Re: Lisgillan Farm Ltd. P1152-01

I refer to previous Agency correspondence of 2nd September last. Please find detailed below the response to the issues raised.

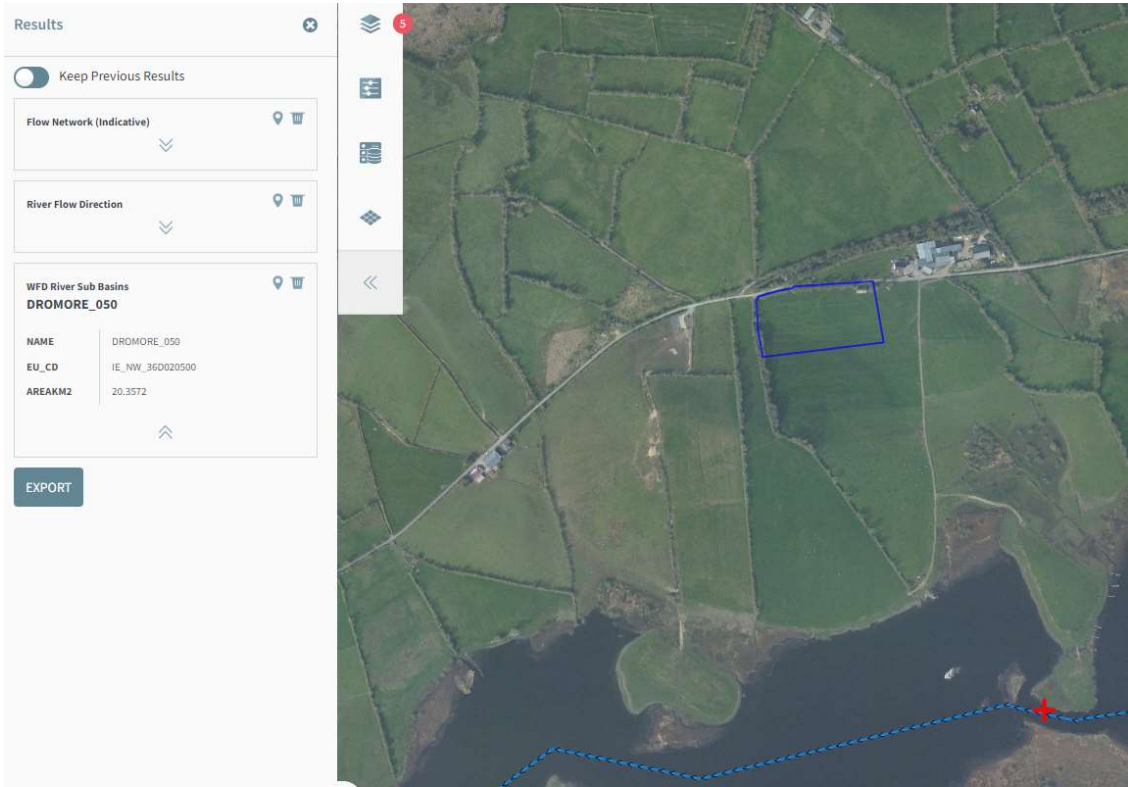
- a) Confirm the location of all stormwater discharge monitoring points with coordinates and update the proposed licenced site plan as required; and

Please refer to enclosed site plan. Coordinates to be confirmed upon installation.

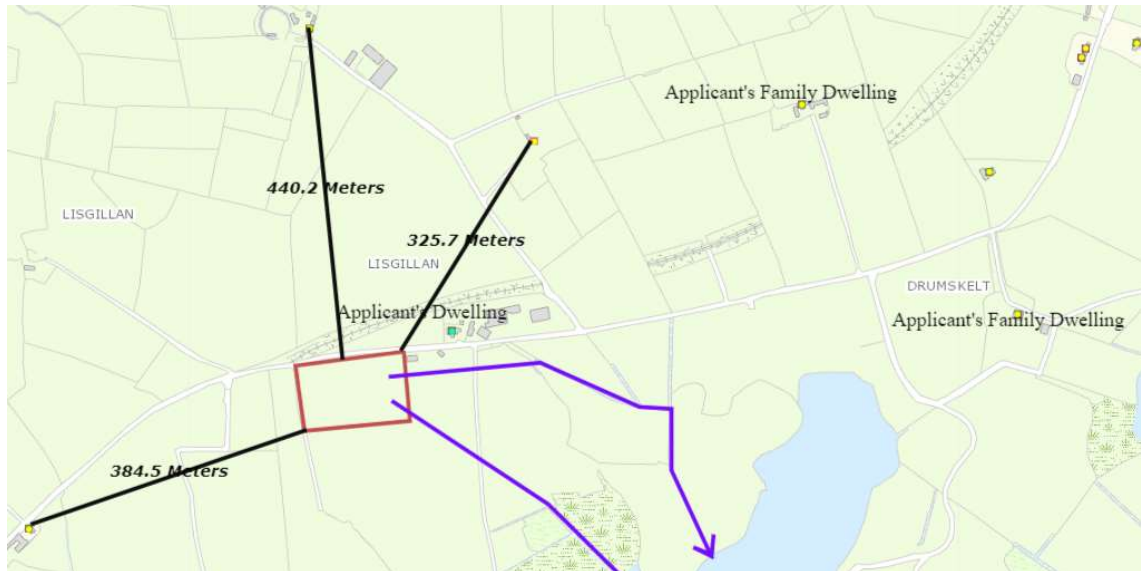
10. Provide a map showing the location and distance from the proposed installation boundary to the closest sensitive receptors. The map should also highlight which sensitive receptors are family dwellings, and which are third party dwellings.

Please refer to map below.
